Date: December 16, 2010

To: B. Conetta (USEPA Region 2)

From: E. Garvey, J. Atmadja, C. Prabhu, X. Wang (The Louis Berger Group, Inc.), J. Kern (Kern Statistical Services, Inc.), and D. Hayes (University of Louisiana at Lafayette)

Subject: Issues in Estimation of Depth of Contamination and Application to Dredge Prism

Figure 1. Estimated depth of contamination for sediments with DoC later proven to be less than or equal to 24 inches (Panel A) and sediments with DoC later proven to be greater than 24 inches (Panel B).

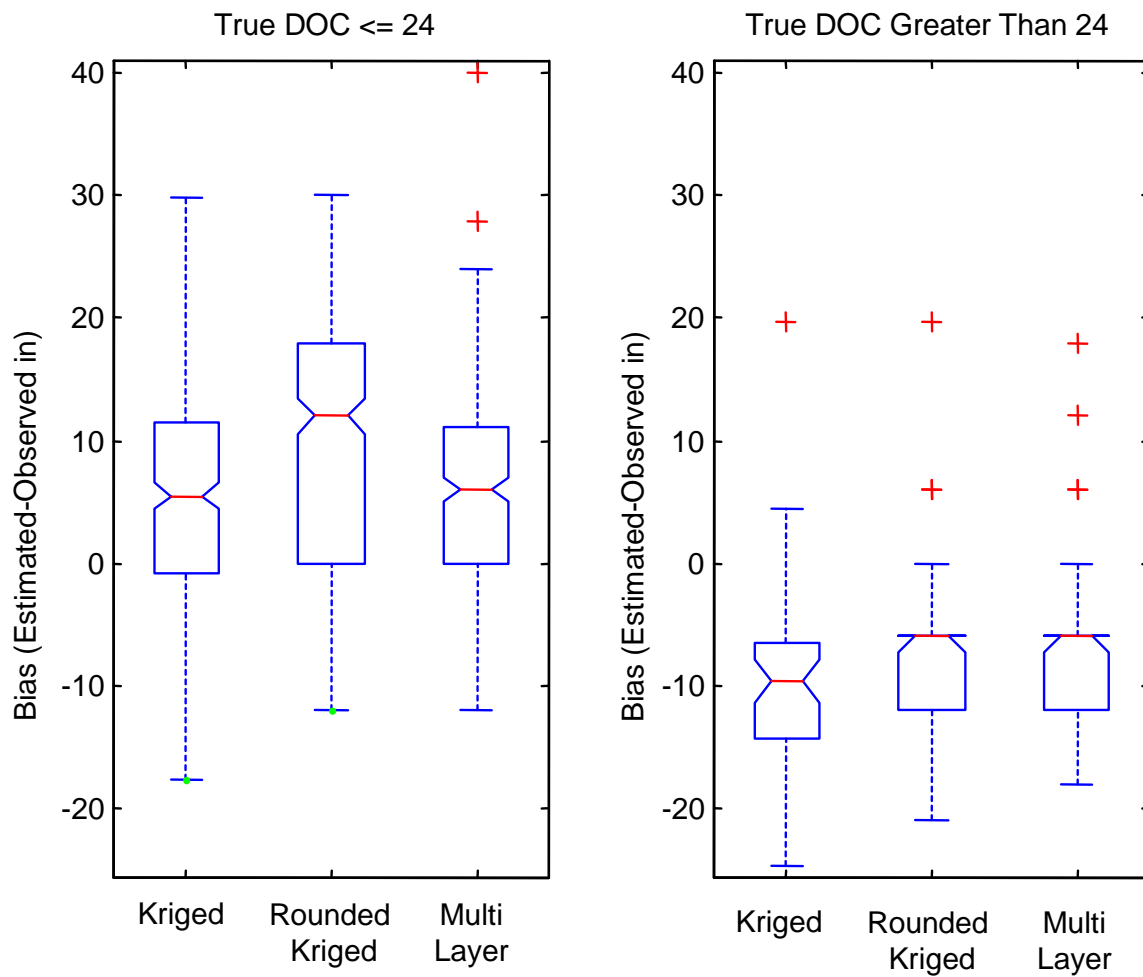
Figure 1 shows side by side box plots of the cross-validation errors. The lower and upper limits of the boxes represent the 25th and 75th percentiles of the error distribution. The red horizontal lines represent the 50th percentile (median) error. Negative errors represent under-prediction and positive errors represent over-prediction of DoC by the interpolation models. Figure 1 indicates that for thicker deposits, DoC was understated by 6 inches or more in 75 percent of locations and understated by 15 inches or more at 25

percent of locations. In contrast, in shallow deposits, DoC was overstated (*i.e.*, predicted elevation was deeper than measured elevation) in 75 percent of locations. This indicates that there was substantial uncertainty in interpolated DoC that if left uncompensated would be expected to cause frequent failure of the Residuals Performance Standard. Roughly speaking, failure to adequately identify DoC in 25 percent of locations could be expected to cause an approximate 25 percent failure rate by area. Importantly, due to the nature of preferential representation of shallower deposits, actual performance in deeper deposits was anticipated to be worse than estimated.³ With this understanding, underestimation of DoC in thicker deposits is clearly of greater magnitude and frequency than that in thinner deposits — the magnitude of errors being even greater than estimated from Level 1A cores.

GE's proposal to add 4 inches to DoC in thicker deposits and 6 inches in thinner deposits runs contrary to results forecasted in 2005 and subsequently verified by Phase 1 dredging in 2009. Uncertainties are clearly greatest in thicker PCB deposits and, therefore, EPA disagrees with the GE proposal to hedge the DoC more in shallow deposits than in thick deposits. It is likely that this approach will result in removal of more non-target sediment relative to potential increase in the percentage of target sediment removed.

Figure 2. Distribution of additional dredge depth as a function of design dredge depth. Values in parentheses represent sample counts of complete (Level 1A) cores.

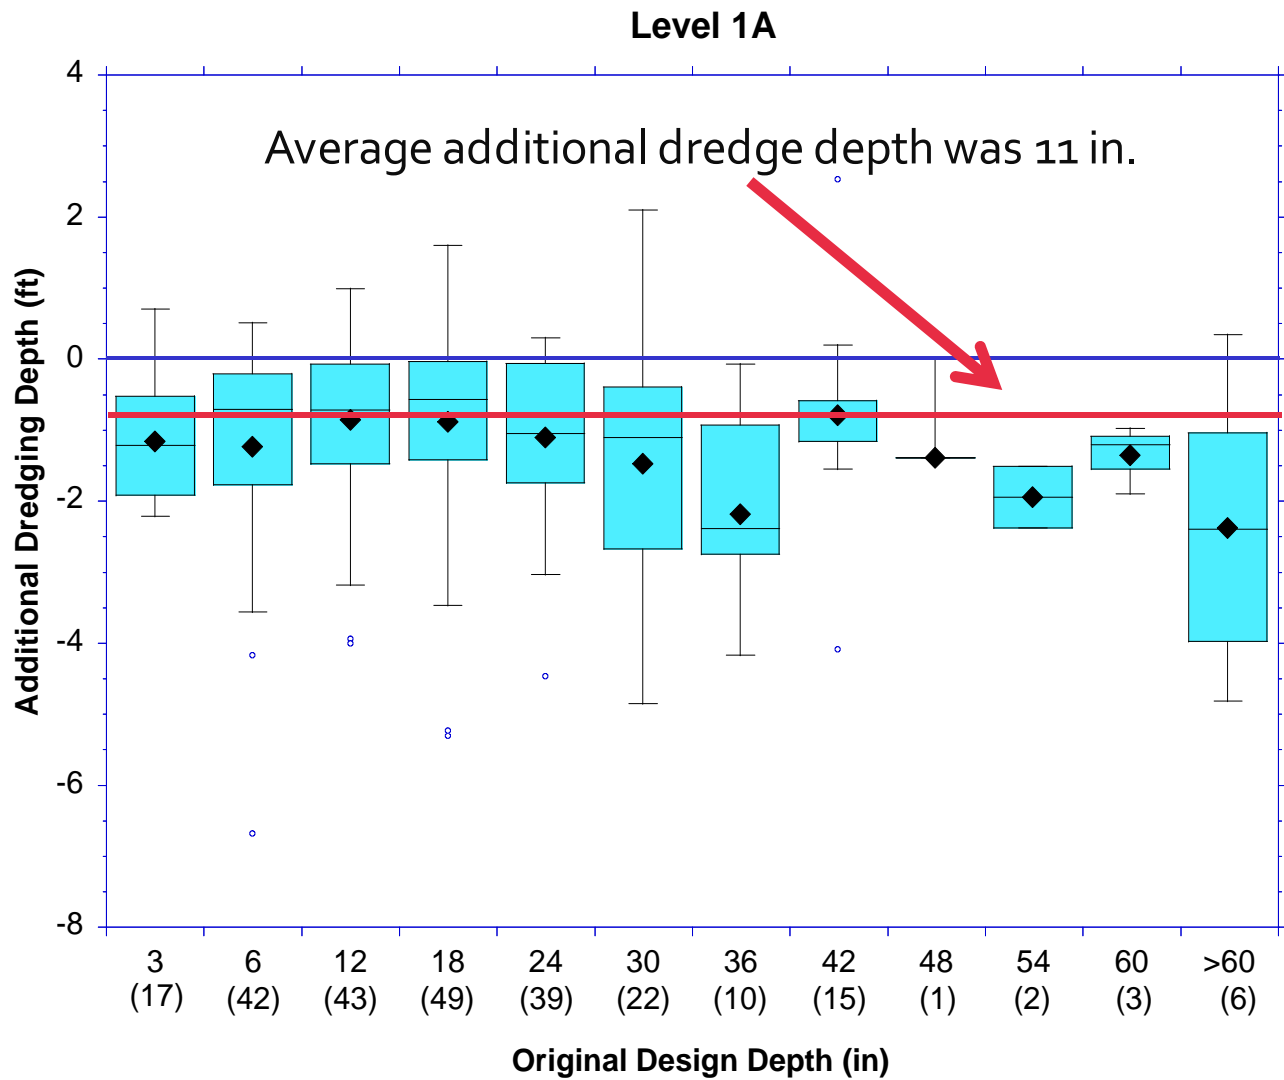
During implementation of Phase 1 dredging, deviations between the final dredge depths and the design DoC averaged 11 inches across all CUs, and were positively associated with design DoC. Figure 2 shows that in Level 1A cores, the thickness of additional dredging increased with the estimated design DoC. It can also be seen that the number of Level 1A cores declines with increasing design depth because the likelihood of penetrating and retaining sediments that capture the DoC is a decreasing

function of PCB deposit thickness. As described previously, this causes estimates of errors in thicker deposits to be understated. Actual performance is expected to be worse than the estimate.

Level 1A cores represent a biased sample of sediments that over-represent thinner deposits and soft cohesive sediments, each of which is more likely to produce conditions conducive to penetration and recovery of sediments. Accurate determination of DoC is more difficult in thicker deposits, because the probability of retaining a complete sediment profile declines with the thickness of sediment, resulting in fewer PCB measurements near the bottom of the contamination layer in thicker deposits. The primary driver of uncertainty in estimated DoC elevations is sample density and this reduction in sample density precisely in the vicinity of the EoC causes increased uncertainty in these areas. Therefore DoC uncertainty is necessarily greatest in areas where soft sediments are thick. GE's proposal to add less overdredge tolerance in thicker deposits runs counter to this controlling physical mechanism that manifested itself in severe understatement of DoC in Phase 1 dredging areas with thicker deposits.

Figure 3. DoC in matched pairs of Level 1A SEDC and Level 1A SSAP cores within a 20 foot buffer.

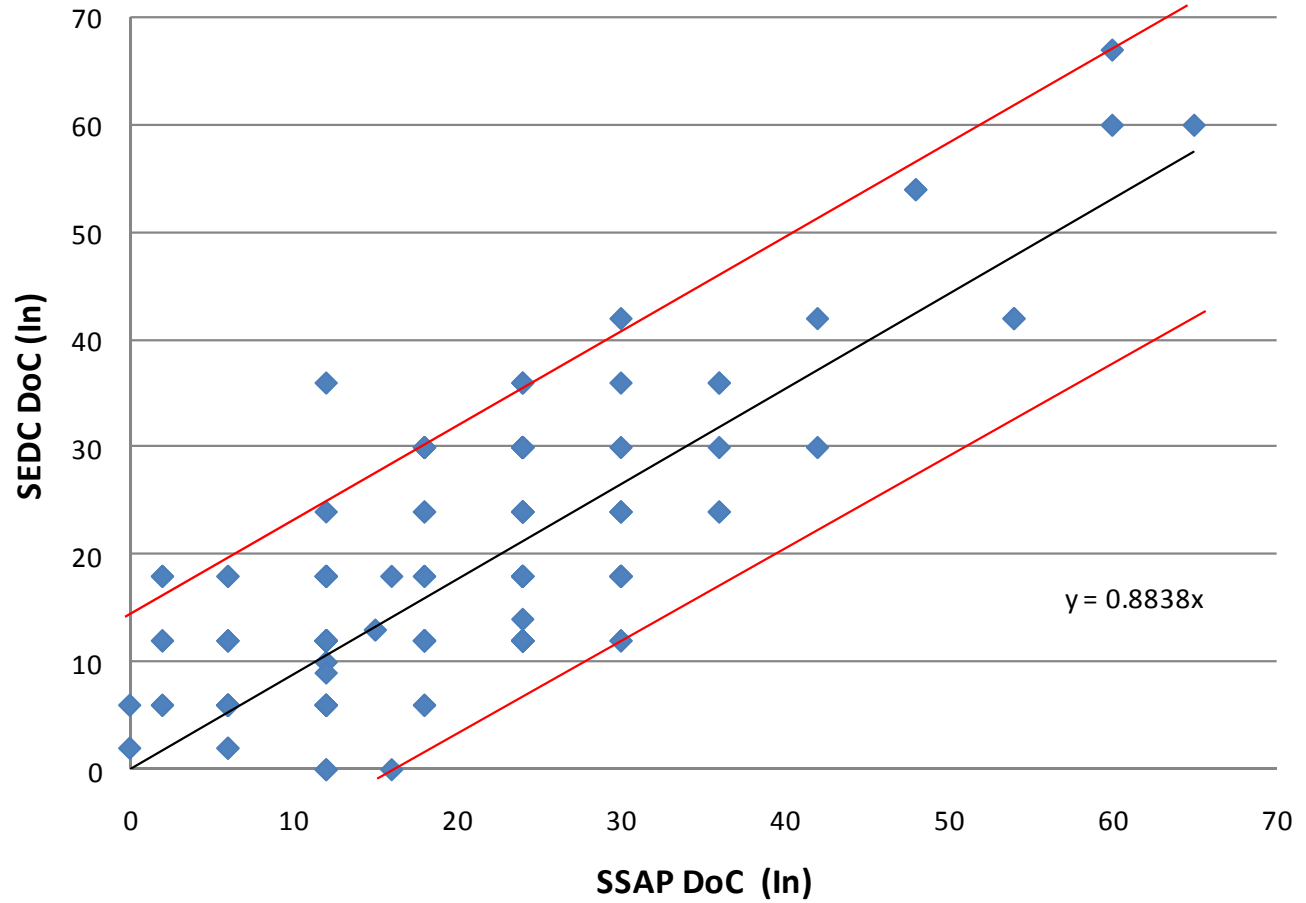
In addition to this moderate bias between the SEDC and SSAP programs there was also substantial random variation between SEDC and SSAP measures. For example for SSAP cores with a DoC of 30 inches, the SEDC DoC measurements ranged from 12 to 42 inches - an approximately 12-inch range of values. The standard deviation of these differences was 8.2 inches, which could be considered to be an estimate of the nugget effect of the DoC variogram. These results are consistent with previous variogram and cross validation analyses that indicated that nugget effect was approximately 9 to 12 inches and that cross-validation, root-mean-squared errors were approximately 10 inches.

In Figure 3, it is also noticeable that the frequency of Level 1A SSAP cores which can be paired with a SEDC core decreases dramatically with deposit thickness. This again reflects the biasing effect of sediment thickness on the likelihood of penetrating and recovering a complete sediment profile in thicker deposits.

The primary conclusion that can be drawn from these data is that substantial uncertainty exists in essentially co-located cores. Uncertainty in DoC at unsampled locations is expected to be generally higher than observed in these closely spaced pairs. While it is anticipated that an increased percentage of complete cores will improve the delineation in Phase 2 areas, the Peer Reviewers' expectation that a highly accurate DoC could be achieved through replacement of incomplete cores with complete cores is not supported by these data. This suggests that dredge design elevations should be developed with an adequate level of compensation for uncertainty to provide a reasonable expectation that the 1-mg/kg total PCB elevation is frequently achieved in the first dredging pass. Given the magnitude of errors observed in

SEDC-SSAP comparisons it is unlikely that deepening the dredging elevations by 4 to 6 inches will substantively improve dredging performance, particularly in thicker deposits where GE proposes to target the DoC less aggressively.

Figure 5. Comparison of Kriged neat-line and prism-based sediment dredging designs at the Fox River, WI. The Kriged neat-line was forecast to remove nearly the same volume of target sediment, while removing much less non-target sediment.

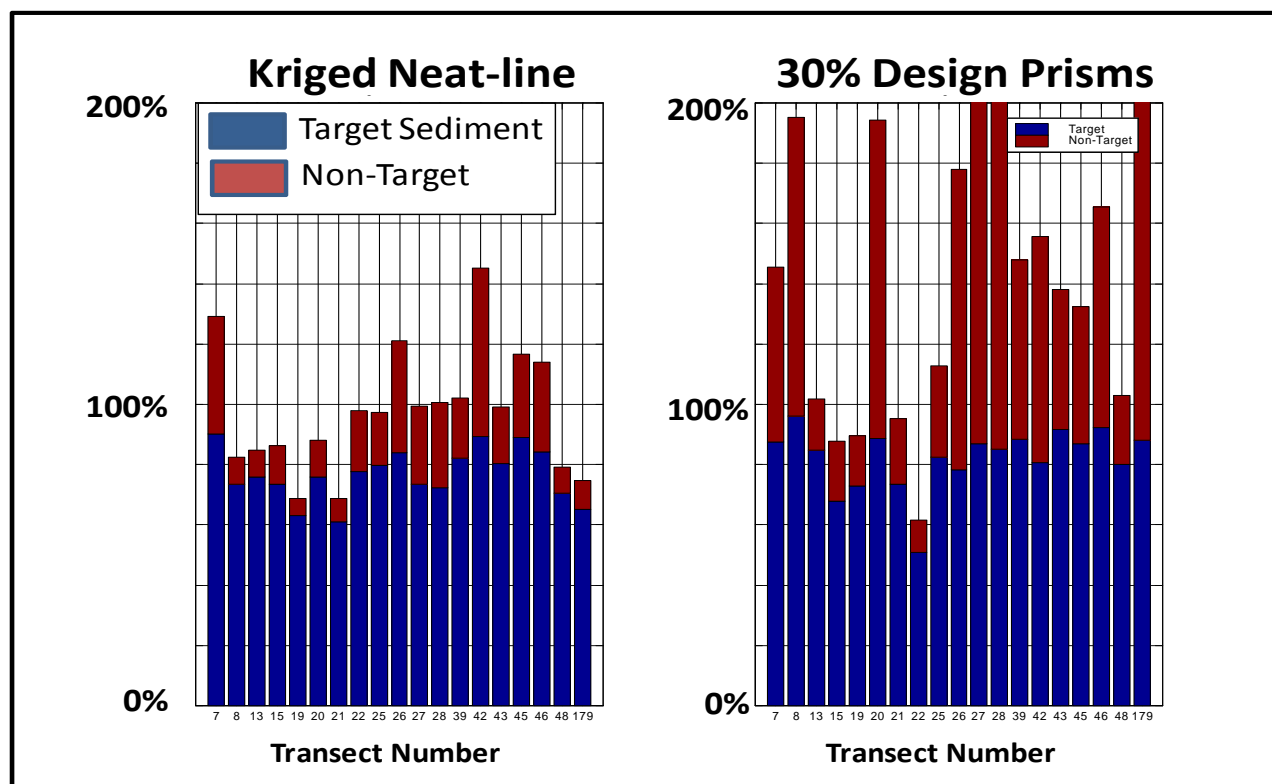
The simulation study provided designers with quantitative forecasts comparing performance of candidate neat-lines. Figure 5 shows a comparison of the amount of target and non-target sediment expected to be removed by two candidate neat-line development procedures. It can be seen that the neat-line based on indicator Kriging was forecast to remove significantly less non-target sediment than the preliminary 30-percent design prisms. The simulation studies also provided a means to forecast expected re-dredging rates which were estimated to be approximately 15 percent in OU3. Actual dredging in 2009 and 2010 resulted in approximately 17 percent re-dredging, well within the error bounds of the 15 percent estimate.

It is EPA's recommendation that GE's dredge elevations for the Hudson River should also be subjected to similar analysis for potential benefits of uncertainty-hedging strategies including strategic use of overdredge tolerance in high-uncertainty areas as well as possible increased sampling density to maximize the proportion of target sediments removed, while balancing the amount of non-target sediments removed and capping performance criteria. It is also EPA's belief that the efficiency of the current overdredge tolerance strategy proposed by GE could be improved through application of a similar rigorous analysis of uncertainties in the estimated EoC surfaces.
